SUBJECT: BZA Appeal No. 17911 (Washington Hilton Hotel)

**SUPPLEMENTAL SUBMISSIONS OF
APPELLANT KALORAMA CITIZENS ASSOCIATION**

Proposed Hilton Hotel redevelopment: Analysis of certain zoning issues

15 Perimeter Test

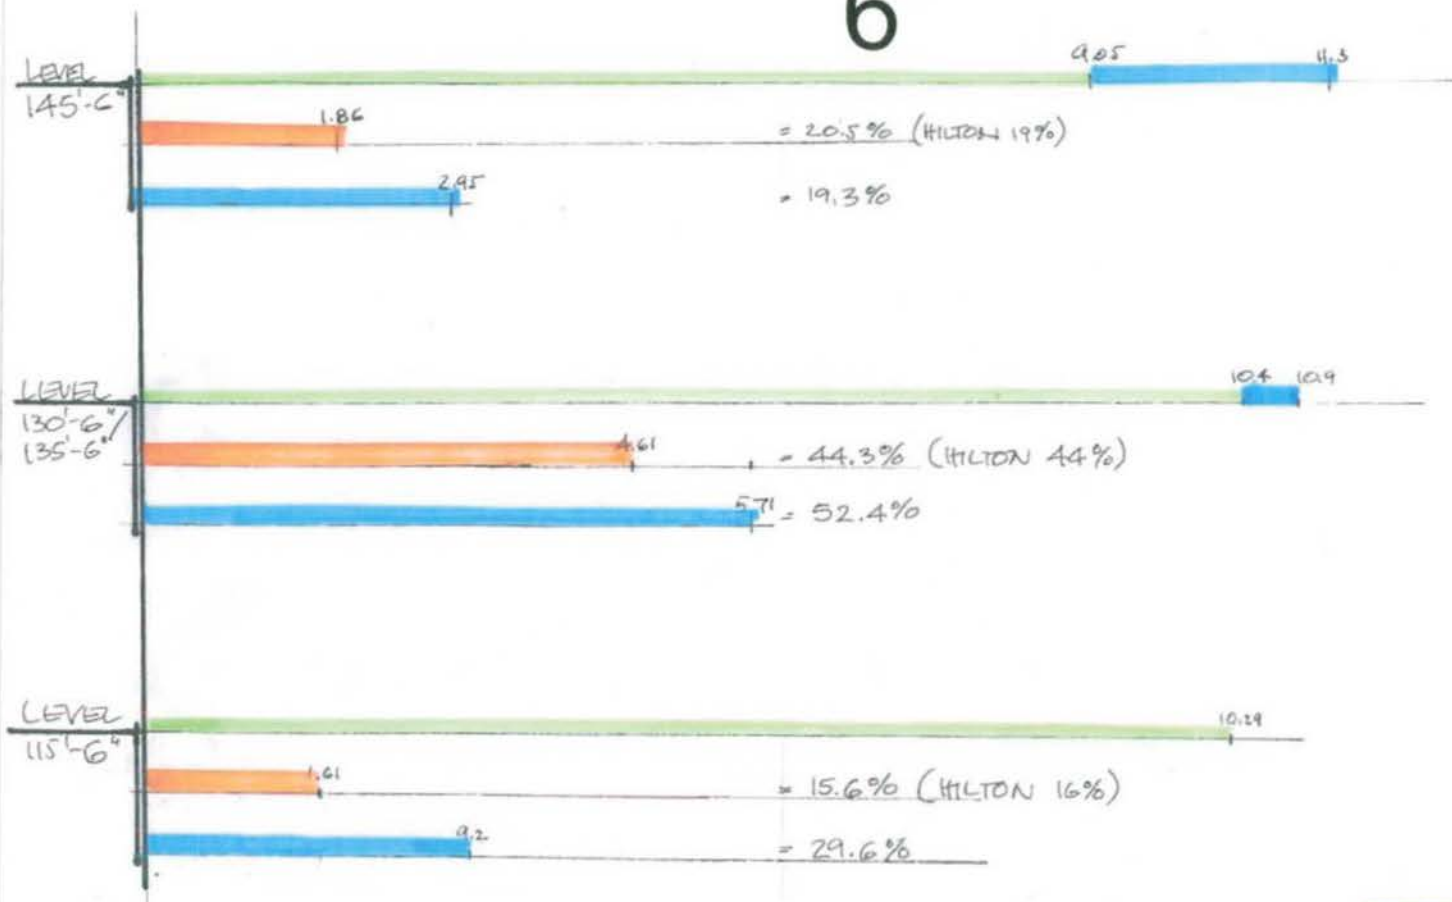
We tried to verify the breakdown of areas as proposed on Sheet 15, labeled "Perimeter Test". (We left aside the issue of building on public land, either above or below ground, for a later discussion.) The graphics shown on that sheet for levels 145'-6", 130'-6"/135'-6" and 115'-6" show several inaccuracies which should be accounted for:

A) Level 145'-6": A structure along Connecticut Avenue has been omitted entirely. Even if it is only for mechanical use, it still %would be part of the "built", not build FAR area. There are even doors leading out onto the turn-around circle. These could be an exit as the lower levels show a staircase leading up to this structure. A quick site visit could verify what the use of the structure is. In any case, it should be accounted for. Furthermore, there is an exit from the kitchen level along the north elevation (slightly east of the center), the double doors clearly at grade level and properly shown on the diagram. What is not shown is the side of this exposed structure where the outside grade slopes uphill towards the west. This is probably not a significant number, but there is an inaccuracy.

B) Level 130'-6"/135'-6": Two areas need corrections: One is similar to that just discussed. Along the north façade at the very east end is a very "green" triangular part of the building which has

been included on the side along 19th Street, but has not been included as the grade climbs up the side of this structure. Another area to be included is where the grand ballroom ceiling is 4' or more above the exterior grade. Even using the "lower" part of the ceiling, the section would indicate a ceiling height of 139'-0". Outside grade of 135' would be the measuring point. In addition, there is a garage structure on the ramp down to the secondary entrance (near the "Potato Chip" Canopy), which has been omitted entirely. This should also be included. And one last item would be the newly proposed stairway and elevator access to the swimming pool, clearly an above-ground feature, but not shown accurately on Lowe's "perimeter test" graphics.

Partial Section 2

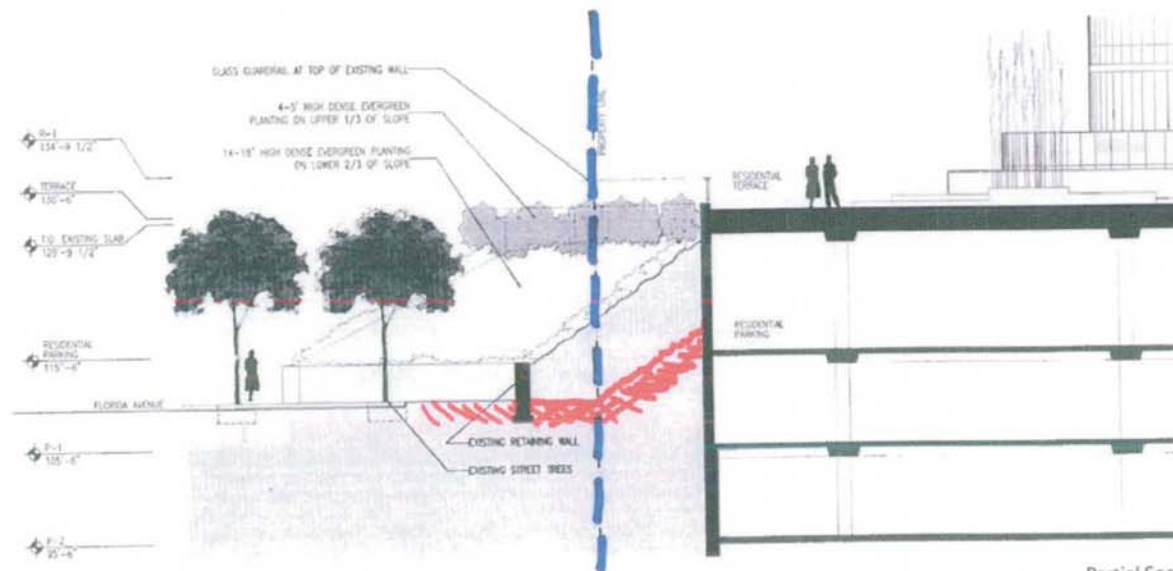
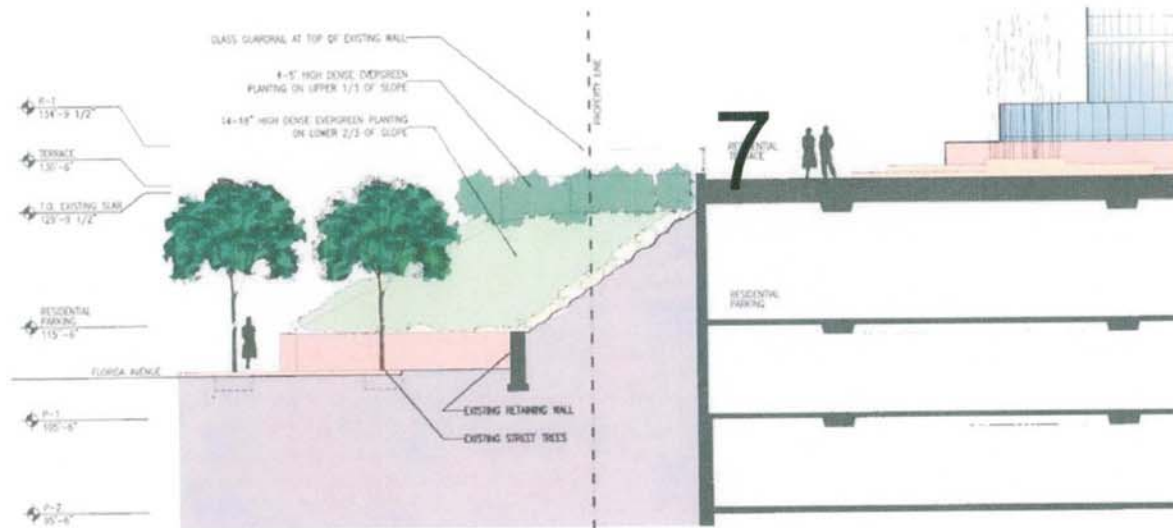
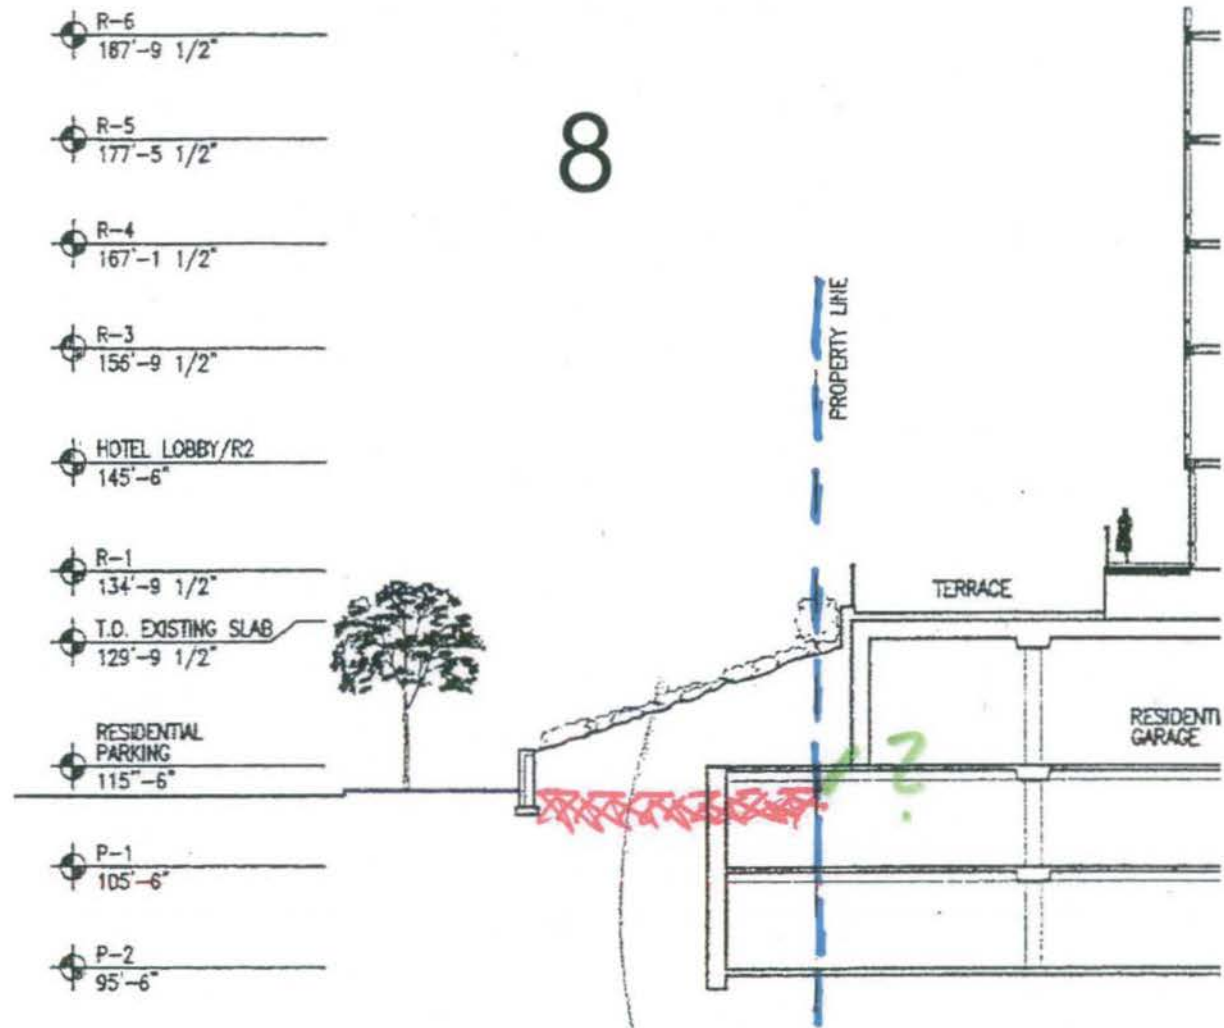
C) Level 15'-6": Looking at the Section provided by Lowe's, and looking at the same time at the "Existing Survey" Plan, it should be noted that the interpretation of what is exterior grades ("adjacent finished grade") has been stretched too far, to cover a grade constructed by building retaining walls on public land and berming earth against the building in an attempt to raise the exterior grade beyond the customary or permissible practice. Typically, any "regrading" on one's own property must meet the existing grade at your property line, from which point you may establish new natural grades, customarily on a 1: 1 ratio. Applying this principal would "expose" the entire length of Level 115'-6" from the corner of Florida Avenue and 19th Street to an exterior grade point of +/- 125' (assuming a 10' ceiling height above the floor elevation of 115'-6", a minimum height for double stacked parking as proposed). This point would be approximately 55' southeast from the corner of the secondary entrance, resulting in a significant stretch of perimeter not accounted for in the proposed calculations. The wall and berm are an existing condition that will be modified at the southeast corner of the property, but the proposed project with its new addition must be in full compliance in all of its areas (as indicated by the fact that Lowe's group has provided FAR figures for the entire proposed structure combining the re-developed hotel and is residential addition). What may have been an oversight previously cannot be taken for granted as to be in "compliance" with the Zoning Ordinance. Furthermore, a topographical map dating from the 1950's before the hotel building was erected indicates that the "natural" existing grades clearly are lower than the artificial build-up by the Hilton project. (The retaining wall built on public land also did not exist before the construction of the Hotel.). Furthermore, as a Topography from the 1950 reveals, the grades along Florida Avenue increased very gradually without any retaining walls

← CLEARLY
VISIBLE
ENTRANCE
(351.2 C)
(351.2 B)

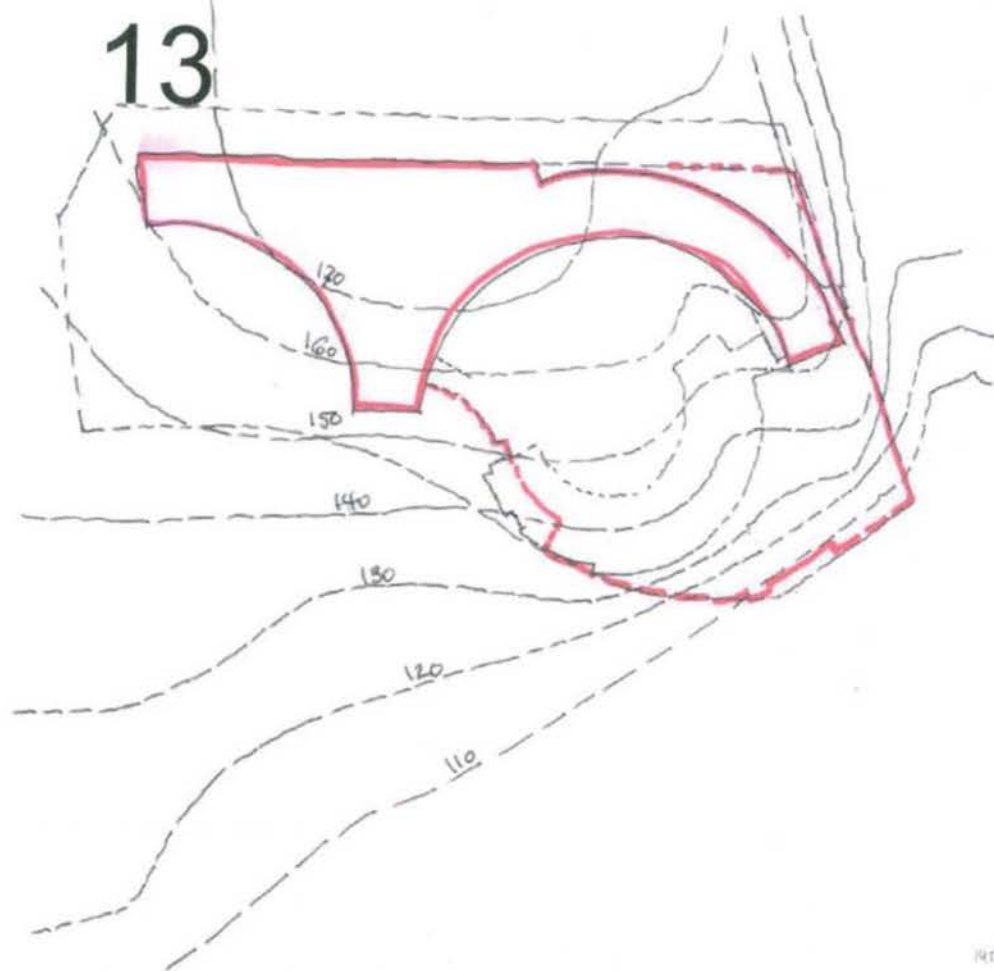
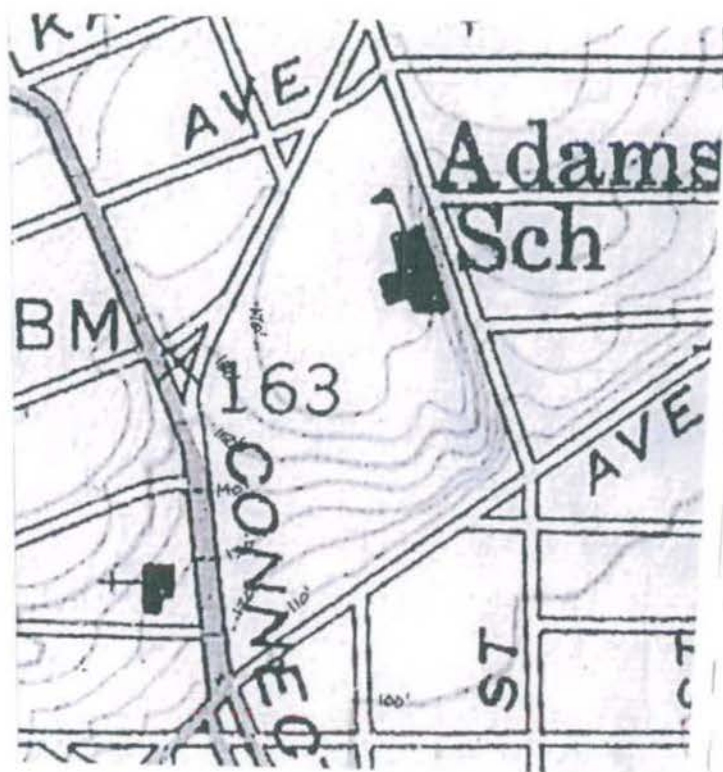
In accordance with 351.2, B and C, There shall be no direct entrances into additional function areas. It appears that on both the T-Street side entrance as well as the 19th Street side additional entrance lead directly into the new exhibition spaces, clearly visible from the sidewalk.

← CLEARLY VISIBLE
FROM SIDEWALK
(351.2 B)
(351.2 C)

05 Proposed Building Plans:
Hotel & Residential

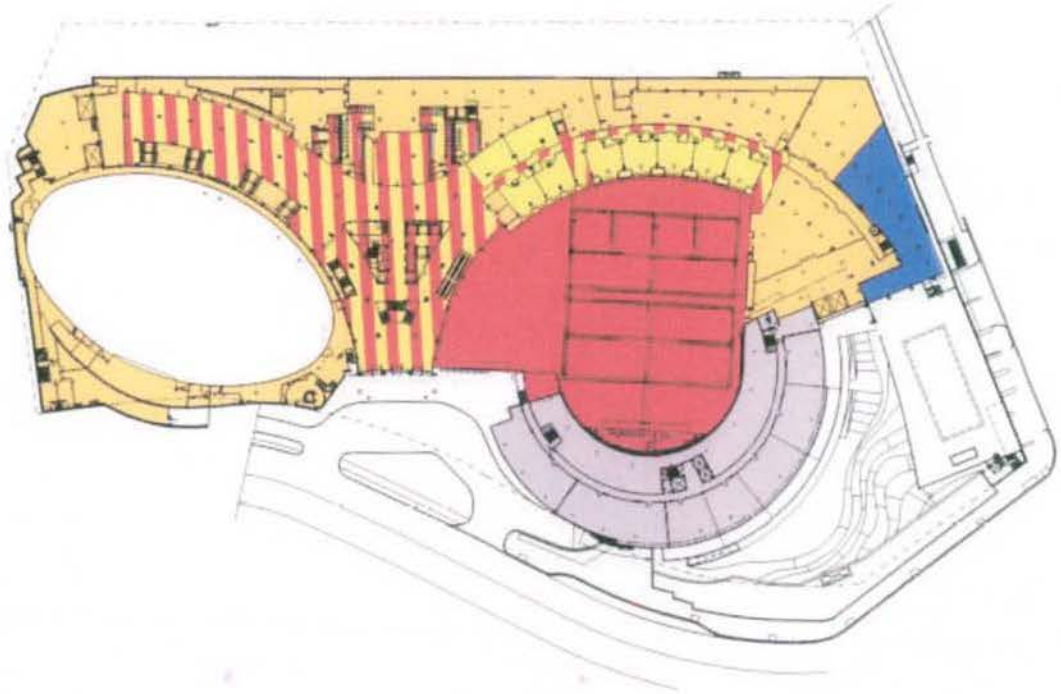
On drawing 06, “Hotel Use Diagrams”, for Level 130’-6”, an excessive amount of interior space is indicated as “Proposed Residential” use. On this floor the residential units along the south side of the new crescent shape are obvious condo units with window exposure. However the inside of the crescent shape has no windows. This is labeled “amenities”. Some amenity space can be located here, with the rule of thumb being anywhere from 3 to 6%, say 7,000 to 15,000 square feet. If one includes the residential area outside the footprint of the crescent-shaped new building, there is substantially more than 15,000 sf. Given the interwoven layout, and the direct adjacency of space proposed as hotel “exhibit space”, it appears that a lot more area should be properly accounted for as hotel use, rather than residential use.
